## Compute Express Link™ (CXL™)

Errata for the Compute Express Link Specification Revision 2.0

*May 2021*

Figure 88a. Successful PM Entry following PM Retry

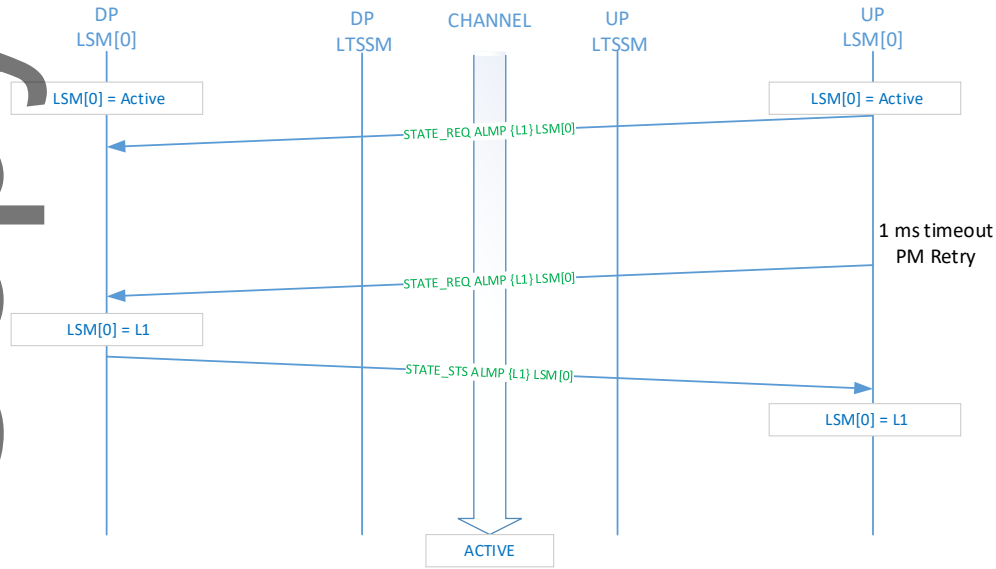
- [The Upstream Port is permitted to retry entry into PM with another PM State Request after a 1ms \(not including time spent in recovery states\) timeout, when waiting for a response for a PM State Request. Upstream Port must not expect a PM State Status response for every PM State Request ALMP. Even if it has sent multiple PM State Requests because of PM retries, if it receives a single PM State Status ALMP, it must move the corresponding vLSM to the PM state indicated in the ALMP. For a Downstream Port, if the vLSM is Active and it has received multiple PM State Request ALMPs for that vLSM, it is permitted to treat it as a single PM request and only respond with a single PM State Status if the vLSM transitions into the PM state. Figure 88a shows an example of this flow.](#)

Figure 88b. PM Abort before Downstream Port PM acceptance

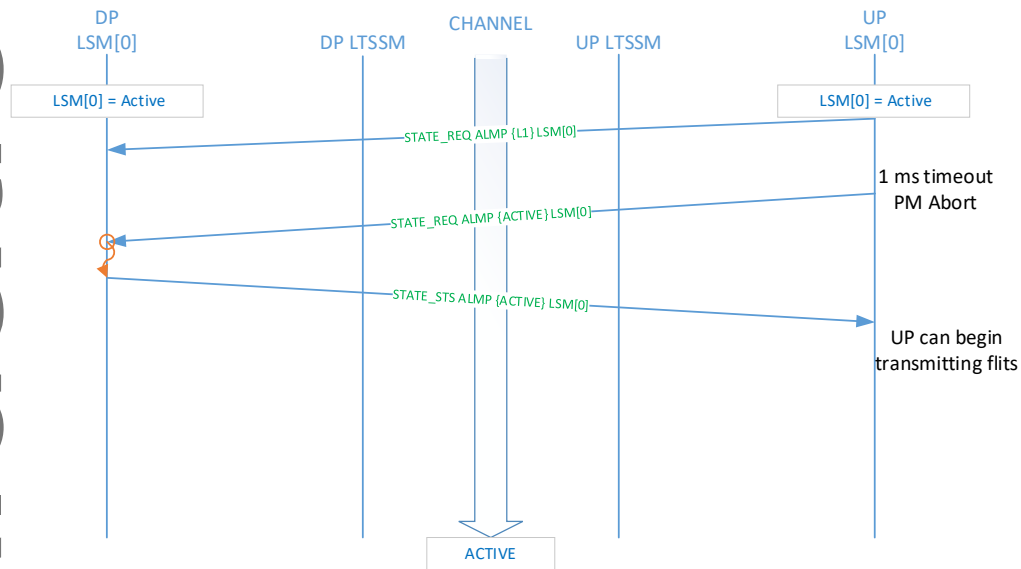
- a. [Downstream Port receives the Active State Request before commit point of PM acceptance. It must abort PM entry and respond with Active State Status ALMP. Upstream port can begin flit transfer towards Downstream Port once it receives Active State Status ALMP. Since the vLSMs are already in Active state and flit transfer was already allowed from Downstream Port to Upstream Port direction during this flow, there is no Active State Request ALMP from Downstream Port to Upstream Port direction. Figure 88b shows an example of this flow.](#)

Figure 88c. PM Abort After Downstream Port PM acceptance

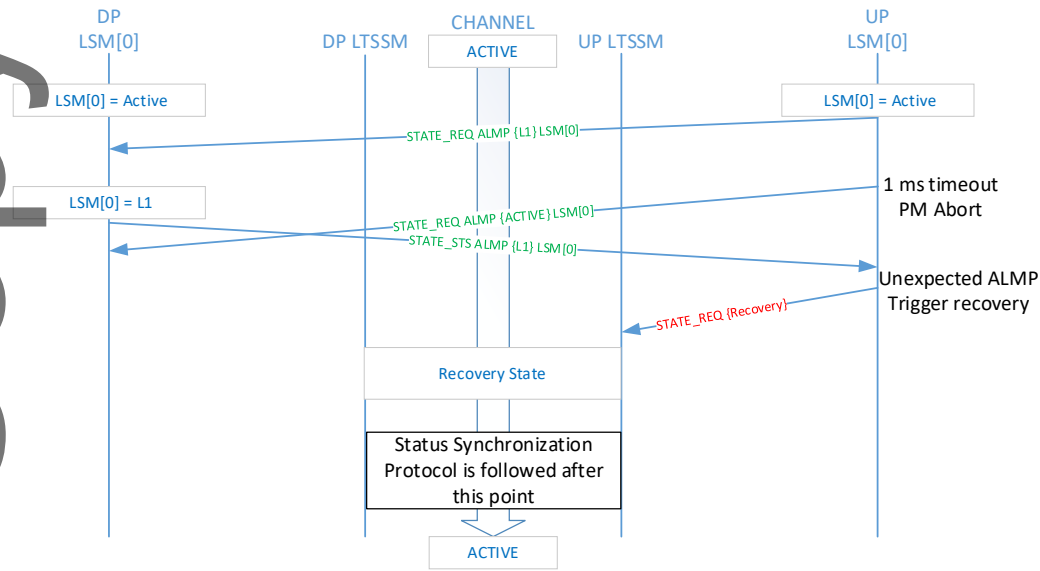
- b. [Downstream Port receives the Active State Request after commit point of PM acceptance or after its vLSM is in PM state. Downstream Port must finish PM entry and send PM State Status ALMP \(if not done so already\). Upstream Port must treat the received PM State Status ALMP as an unexpected ALMP and trigger link Recovery. Figure 88c shows an example of this flow.](#)

**Figure 177. Early Termination and Transmission of Truncated MAC Flit**

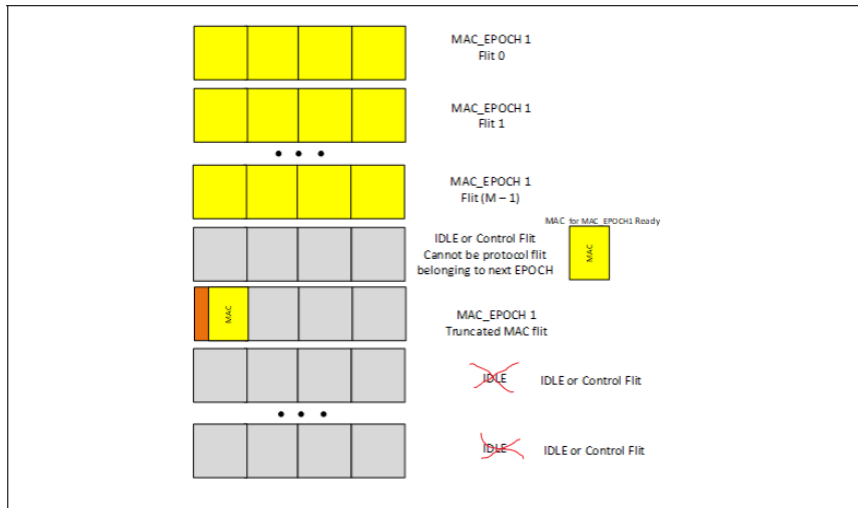
As part of the Truncated MAC (TMAC) flows discussed CXL2.0 Section 11.1.9 there are two figures which show examples of the flits sent as part of the TMAC flow. The figures have created confusion because they show "IDLE" as the only flits following the sending of TMAC, and before the TMAC it shows "IDLE or CONTROL". To avoid deadlock following the TMAC flit, either IDLE or other control flits are allowed (no protocol flits). This errata will correct the figures where red "x" shows the old text which is replace with text to the right of the "x".
